Area North Committee – 25 September 2013

Officer Report On Planning Application: 13/02925/FUL

Proposal:	Installation of ground mounted photovoltaic solar array to provide 6 MW generation capacity together with inverter systems; transformer stations; sub-station; internal access track; landscaping; security fencing; associated access gate and removal of one Ash tree protected by Tree Preservation Order (Re-submission of previously withdrawn application) (GR:348938)
Site Address:	Land Adjacent A303 Tintinhull Forts, Tintinhull
Parish:	Tintinhull
ST MICHAELS Ward (SSDC Member)	Cllr Jo Roundell Greene
Recommending Case Officer:	Lee Walton Tel: (01935) 462324 Email: lee.walton@southsomerset.gov.uk
Target date:	17th October 2013
Applicant:	Luminosity Energy
Agent: (no agent if blank)	Mr Colin Virtue First Floor South Wing Equinox North Great Park Road Almondsbury. Bristol BS32 4QL
Application Type:	Major Other f/space 1,000 sq.m or 1 ha+

**Appendix A: Annotated photographs of the view from
St Michael's Hill (from top of tower)**

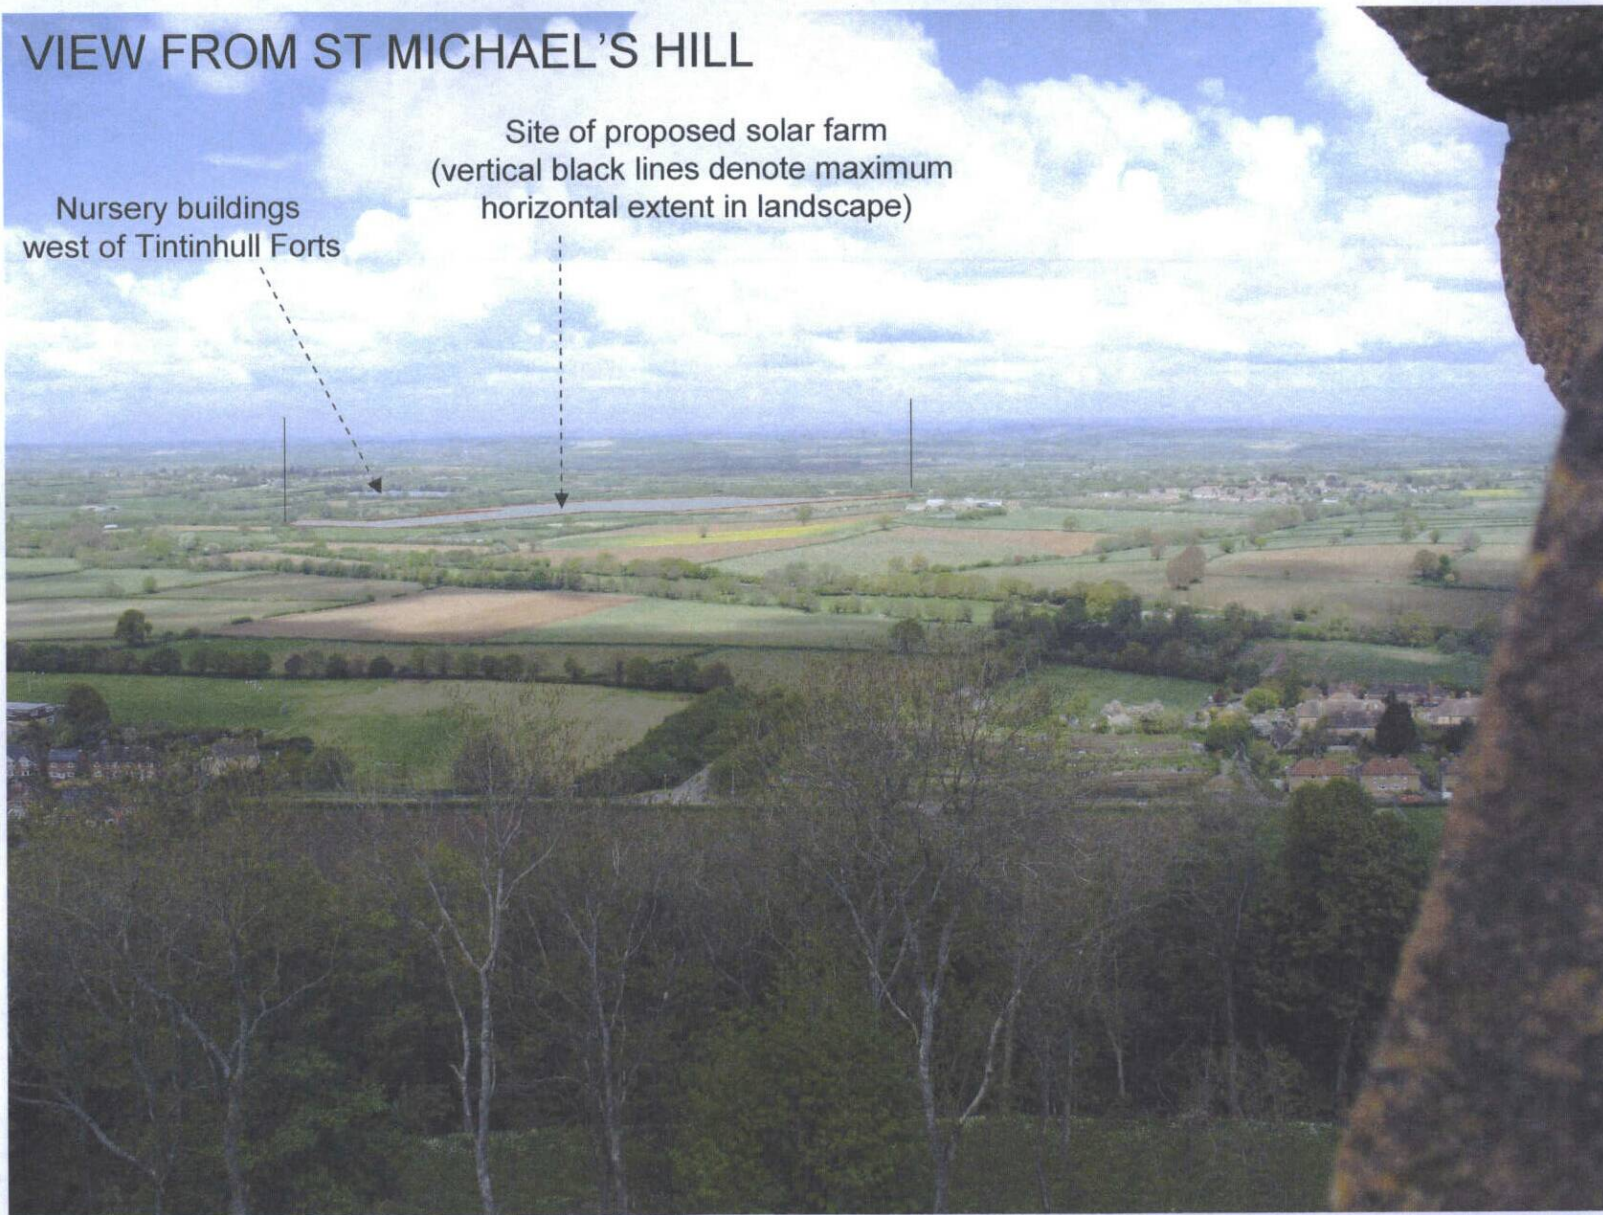
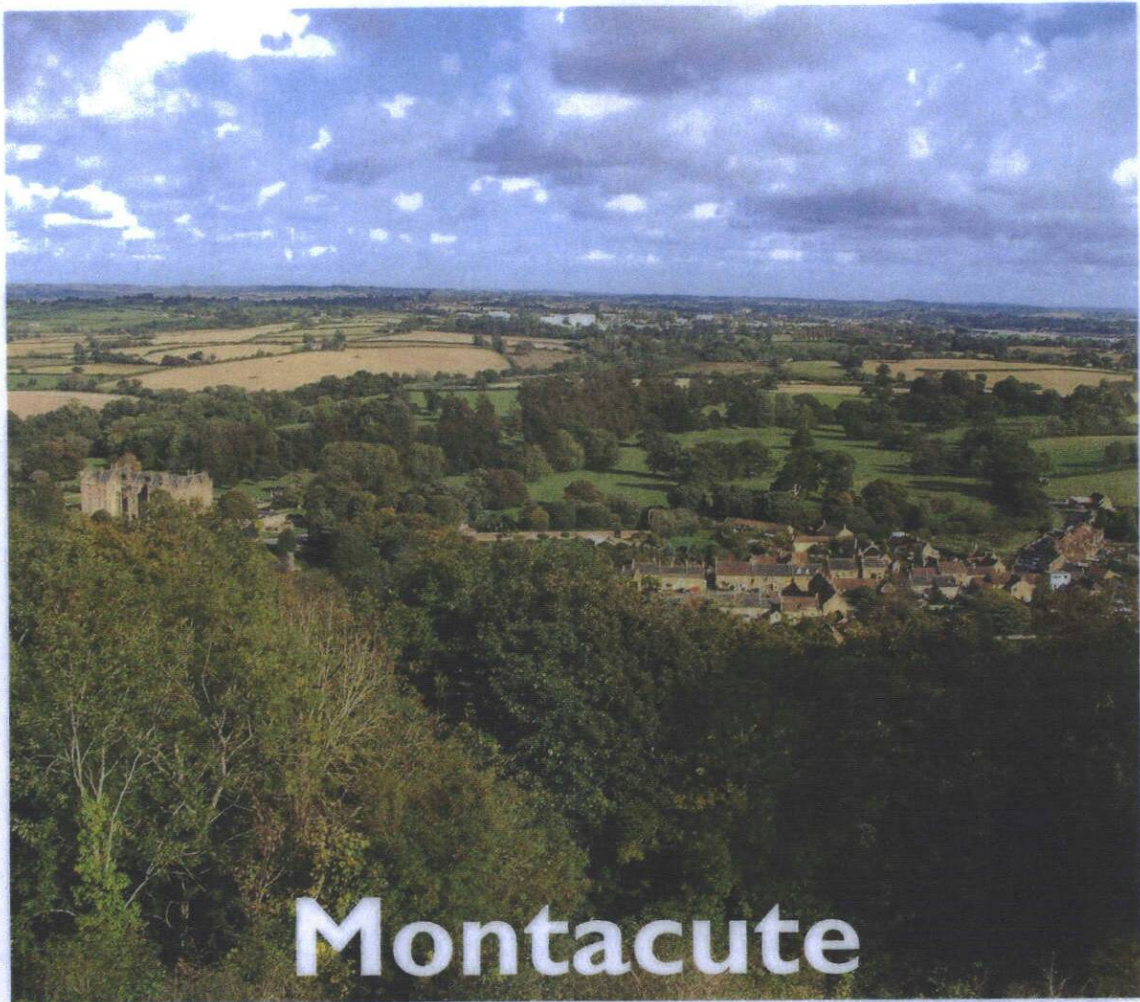
The Pegasus landscape and visual impact assessment concludes that: “On a clear day, receptors may have distant views of the Development Site, partially screened by intervening vegetation”. It suggests that there would be a “minor change in the view”, and that the proposed landscaping would break up views to the site. It considers the sensitivity of this receptor to be “high”; rates the magnitude of impact as “low”; and the likely significance of effect as “moderate adverse”.

The Pegasus assessment concludes as follows: "Receptors will have elevated, direct views of solar panels and associated infrastructure including inverters and a substation. The proposed development will introduce built infrastructure into views of a largely rural landscape with a number of urban elements, including the A303 which is a major element within the view. There is like to be a major change in the view, the proposed development is likely to become a dominant feature and cause a noticeable deterioration in views from this receptor. The sensitivity of this receptor is considered to be low. The magnitude of impact will be high. The likely significance of effect is therefore considered to be moderate adverse".

In response to the above, the A303 can be seen to represent a rather more modern – and larger scale – version of Fosse Way, but it is considered that the view there onwards is an entirely a rural view. The very dominant and industrial scale feature taking up a large extent of the foreground would be the proposed solar farm, complete with boundary security fencing. Given that this is the earliest historic view of St Michael's Hill, the sensitivity of this receptor is considered to be high, and the significance of effect major adverse.
